## **HARRELL SUBDIVISION**

APPLICATION NUMBER 15 DATE November 20, 2003

# HARRELL SUBDIVISION

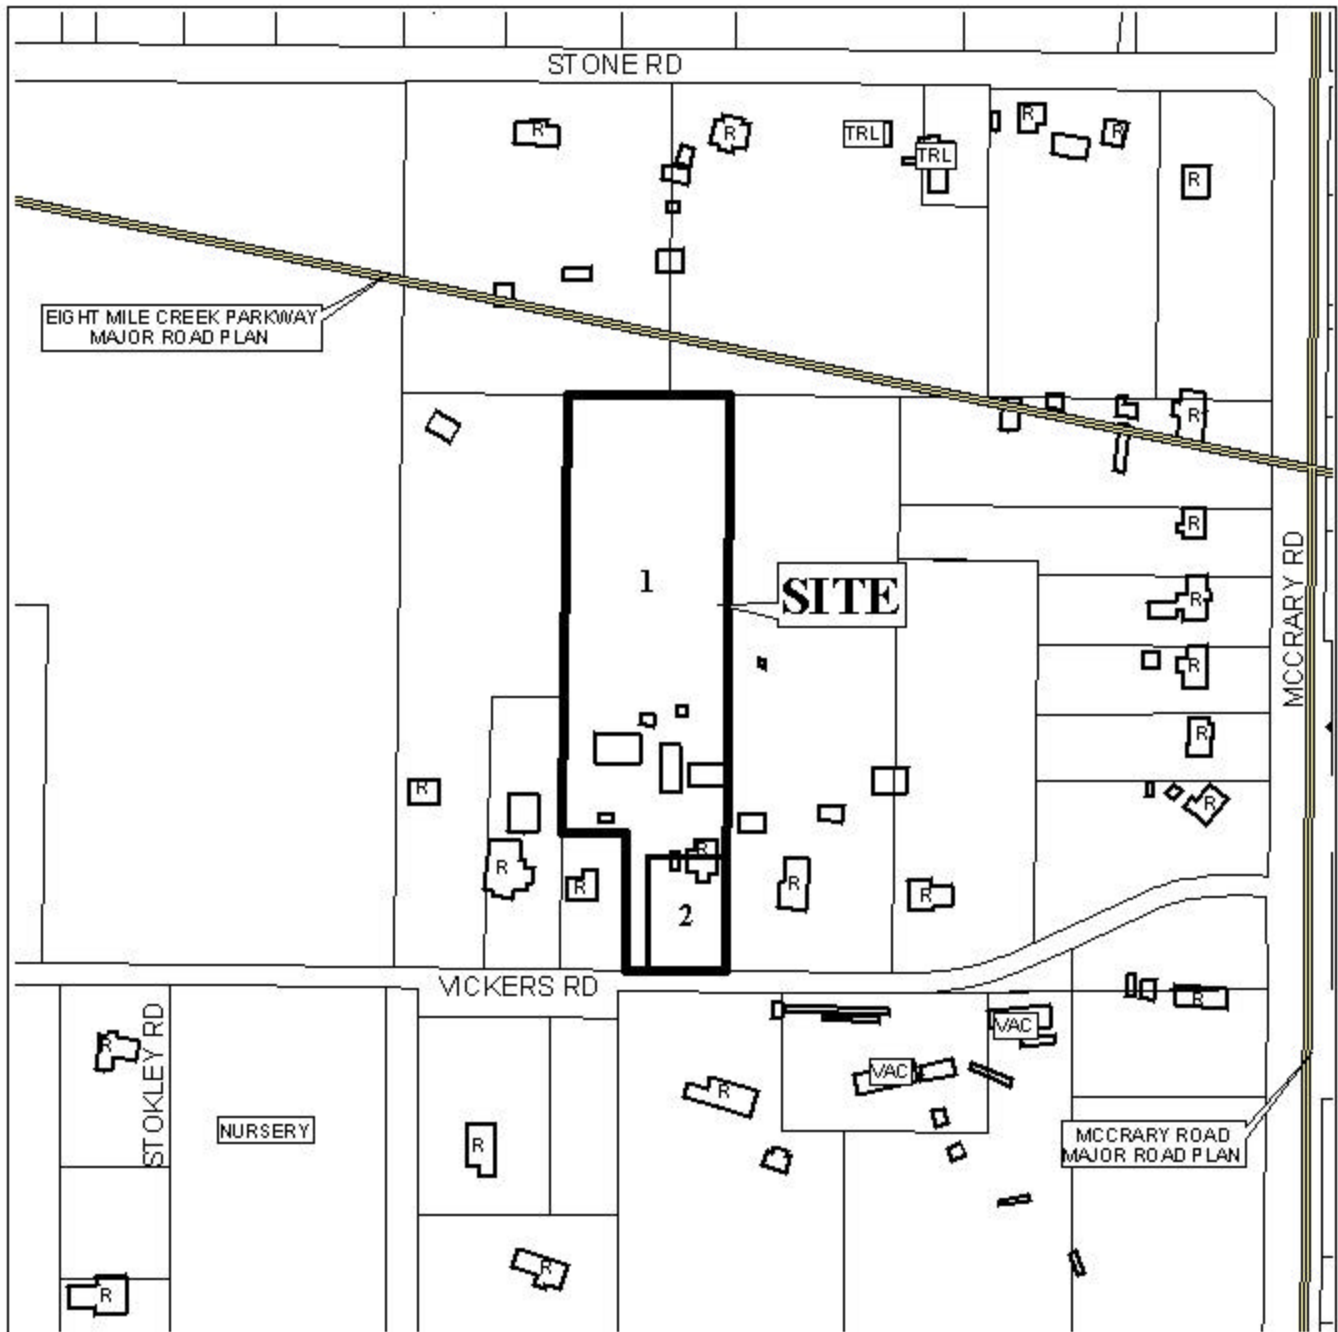
As a method of access management, the placement of a note on the final plat stating that Lots 1 and 2 are limited to one curb cut each to Vickers Road, with the size, location and design to be approved by County Engineering, should be required.

Additionally, the placement of a note on the final plat stating that Lot 1 will not be further subdivided unless additional frontage (50' in width) is provided to an improved public road. Also, with Lot 1 having only a 25-foot frontage along Vickers Road, a waiver of Section V.D.3. of the Subdivision Regulations would be required.

This site is located in the County, thus a note should be placed on the final plat stating that any lots which are developed commercially and adjoin residentially developed property must provide a buffer, in compliance with Section V.A.7. of the Subdivision Regulations.

The 25-foot minimum building setback lines are not shown but would be required on the final plat.

With a waiver of Section V.D.3., the proposed plat meets the minimum requirements of the Subdivision Regulations and is recommended for Tentative Approval subject to the following conditions: 1) the placement of a note on the final plat stating that Lots 1 and 2 are limited to one curb cut each to Vickers Road, with the size, location and design to be approved by County Engineering; 2) the placement of a note on the final plat stating that Lot 1 will not be further subdivided unless additional frontage (50' in width) is provided to an improved public road; 3) the placement of a note on the final plat stating that any lots which are developed commercially and adjoin residentially developed property must provide a buffer, in compliance with Section V.A.7. of the Subdivision Regulations; and 4) the placement of the 25-foot minimum setback lines on the final plat.
